ADDENDUM NO. 2

DATE: 05/07/26

PROJECT: Opstad Elementary School Parking Lot Expansion
Snoqualmie Valley School District

L1.00

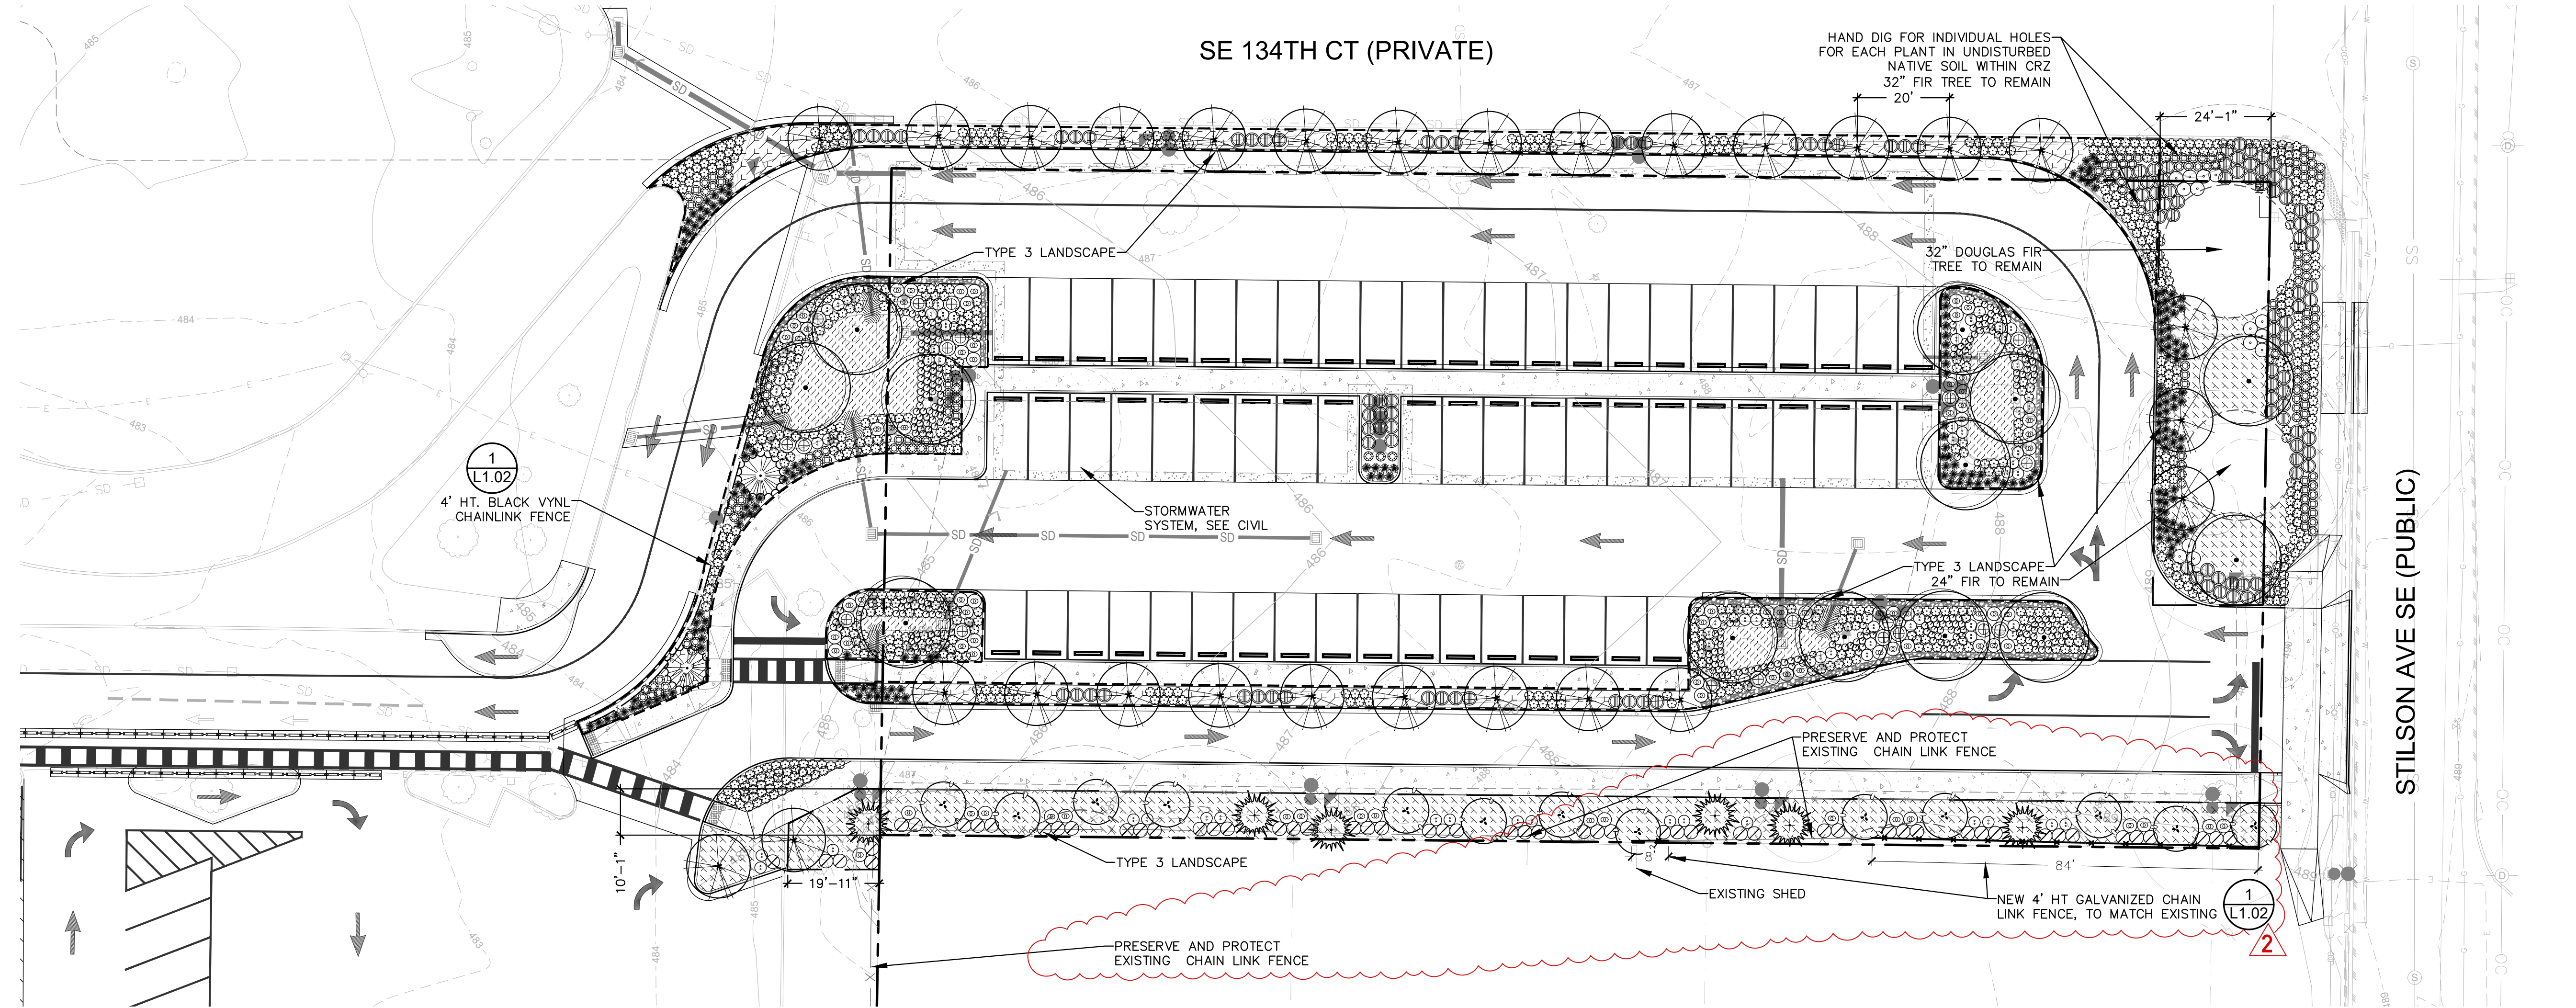
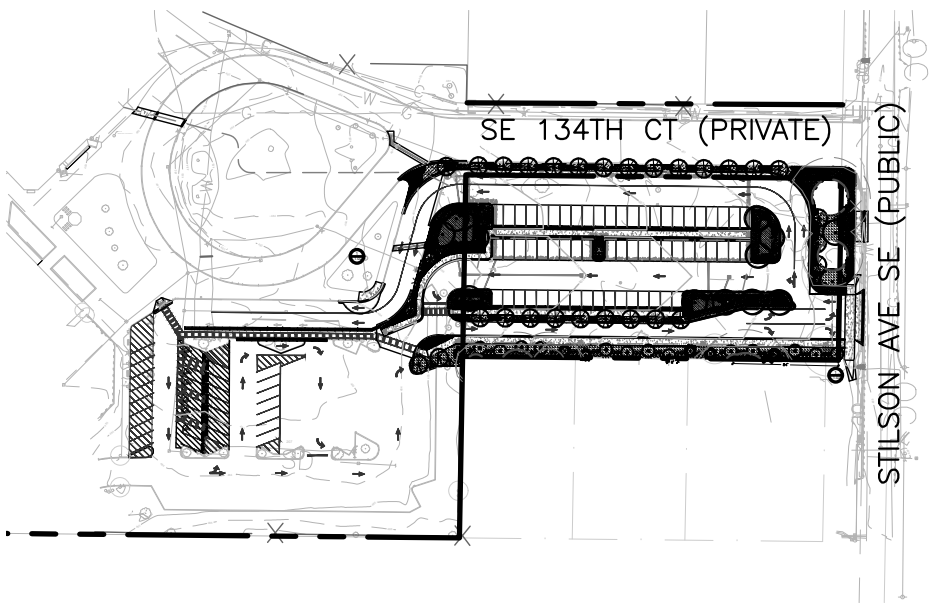
- Item #L01 SHEET L1.00 – LANDSCAPE PLAN
ADD #02 A. **Add** NEW “4” High Galvanized Chainlink Fence” along south side of property line in SE corner of site as indicated on plan.
- Item #L02 SHEET L1.02 – LANDSCAPE DETAILS
ADD #02 A. **Revise** Detail 1 to include Galvanized fence finish as indicated.
